2.A TOPICAL RESPONSE TO COMMENTS

TR-2 PARKING

Rowland Heights Plaza and Hotel Project
 Source: Parallax Investment Corporation; Architects Orange; Gene Fong Associates, 2016.

Shared Parking Demand by Hour: 6:00 P.M.

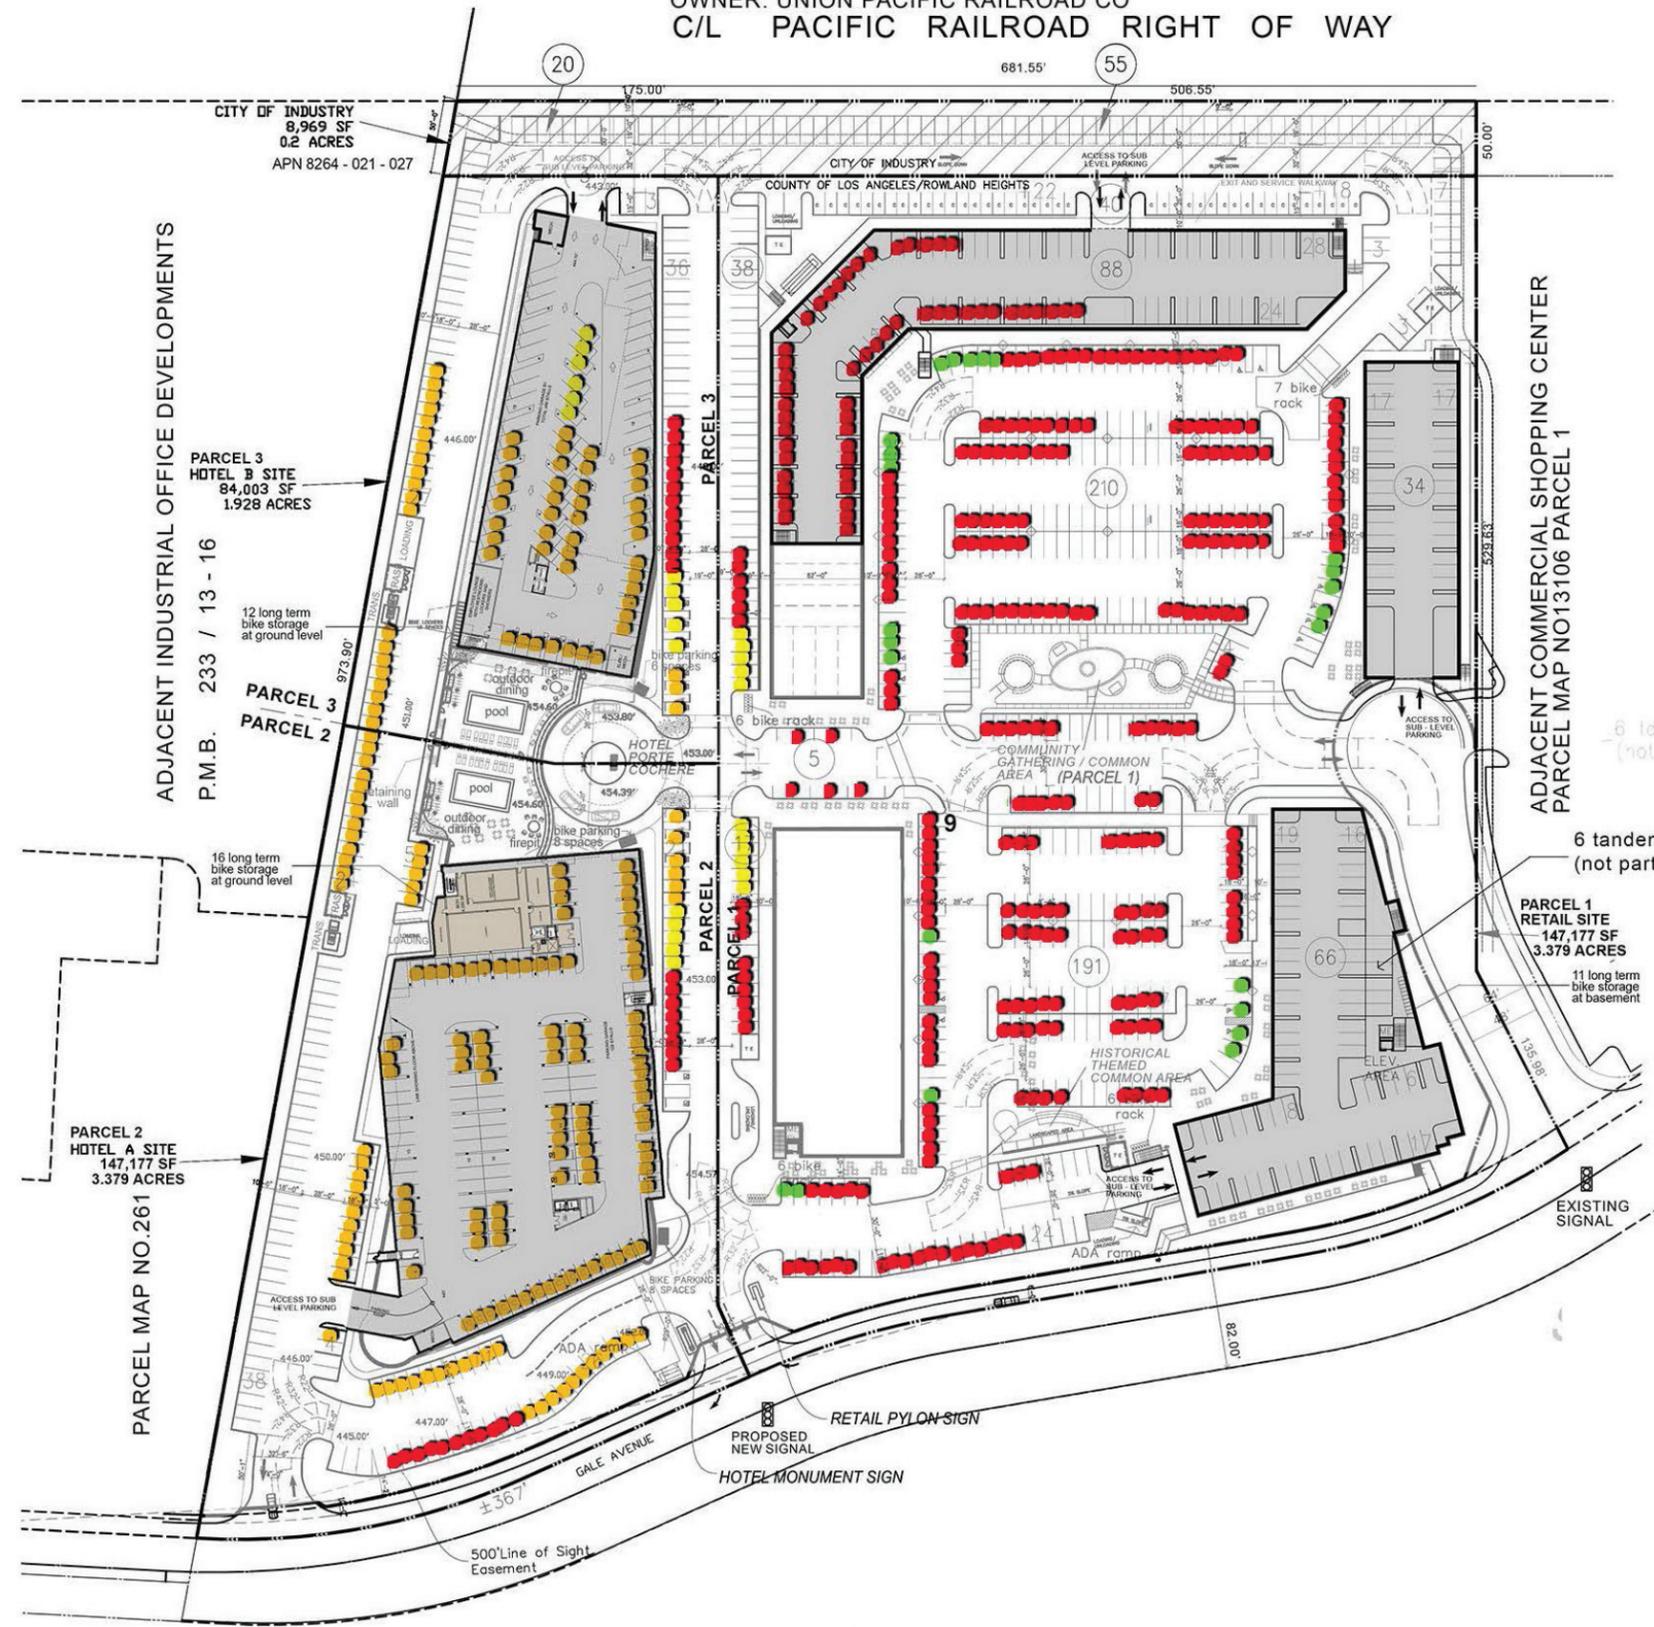
To further demonstrate the aspects of the proposed shared parking program for the Project, exhibits have been prepared to illustrate the potential parking utilization at the site during a weekday at the following hours, and are incorporated into this Topical Response as **Figure 2-1, Shared Parking Demand by Hour: 6:00 A.M.**; **Figure 2-2, Shared Parking Demand by Hour: 11:00 A.M.**; **Figure 2-3, Shared Parking Demand by Hour: 1:00 P.M.**; **Figure 2-4, Shared Parking Demand by Hour: 6:00 P.M.**; and **Figure 2-5, Shared Parking Demand by Hour: 11:00 P.M.** Figure 2-1, the 6:00 A.M. exhibit, expectedly shows cars parked around the two hotels, with substantial vacancies (i.e., calculated at 938 surplus spaces) available on the balance of the Project Site. At 1:00 P.M., office parkers are shown on Parcel 1, the Commercial Center, but at 6:00 P.M. (after many office workers have departed), these same parking spaces on the Parcel 1 Commercial Center are now used by restaurant patrons. By 11:00 P.M., commercial parking demand has subsided and there is a substantial parking surplus parking available to serve the hotels.

1,122 TOTAL DEMAND AT 6:00 PM
 1,203 PARKING SUPPLY
 81 SHARED PARKING AT 6:00 PM
